**Pennsylvania Technical Advisory Committee
On Diesel Powered Equipment**

January 7, 2008

RE: Recommendation for FINAL approval of a Brookville Equipment Corporation Brookville Model 20T193D 20 Ton Locomotive with a Cummins QSB 6.7 193HP diesel engine and a M30 DST Filter (M267 Total System).

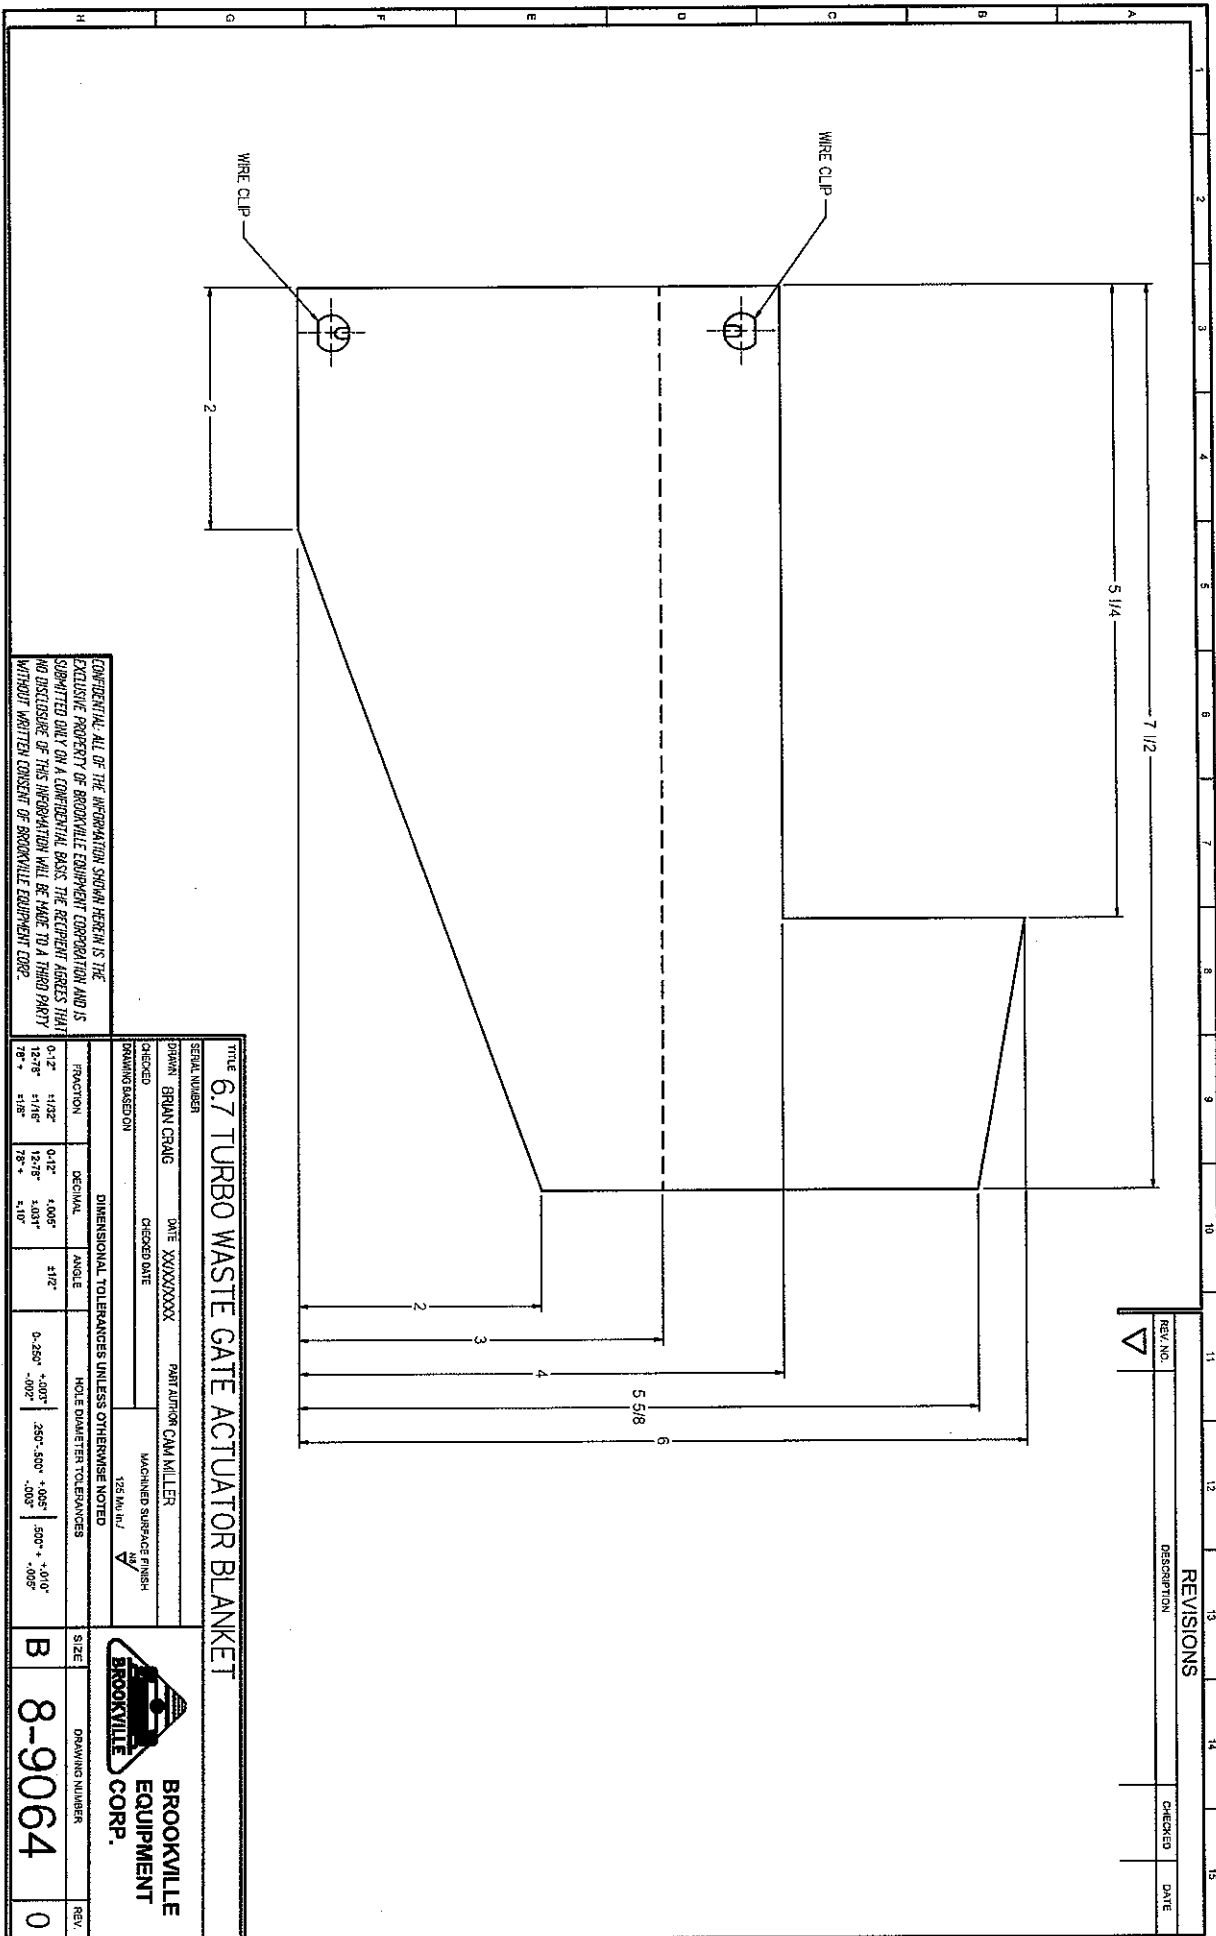
The Engine was lugged and measurements with a heat gun and 306 degree heat crayon showed that the temperature on top of the turbo arm bracket was still above 302 degrees at around 420 degrees F. This was the only significant area that had a surface temperature above 302 degrees. Brookville proposed to fabricate a "Fire Blanket" material wrap to install on the turbo arm bracket which would still allow movement of

the arm to operate the waste gate valve. A temporary wrap was constructed from the "Fire Wrap" material previously used on the blanket wrap. After it was installed on the turbo arm bracket, the engine was again started and lugged until the transmission oil temperature shut down was activated at 240 degrees. The maximum surface temperature on the turbo arm bracket as measured with the 306 degree heat stick and heat gun was found to be 130 degrees F. There was no surface temperature on any turbo significant parts above 302 degrees F. This satisfied the requirement under Section 203-A-(b)(3).

Brookville obtained measurements and agreed to manufacture a more permanent wrap made out of the same "Fire Wrap" material to replace the temporary wrap installed that day. A drawing of the permanent wrap is provided in Attachment 2.

- The temporary "Fire Wrap" material wrap on the turbo arm bracket should be replaced with the permanent "Fire Wrap" part (as shown in Attachment 2) **on the first 100 hour maintenance performed after the part is delivered.** The installation of the permanent wrap shall be noted in the 100 hour maintenance record when it is installed. The BMS should be notified when this permanent part is installed.
- This recommendation is provided with the understanding that the General Specification Sheet (Attachment 1-Rev) be strictly adhered to. As stated in the September 6, 2007 recommendation to the director, we are also recommending FINAL approval of an alternate test procedure for Sections 217-A and 218-A of the act (Attachment 3).
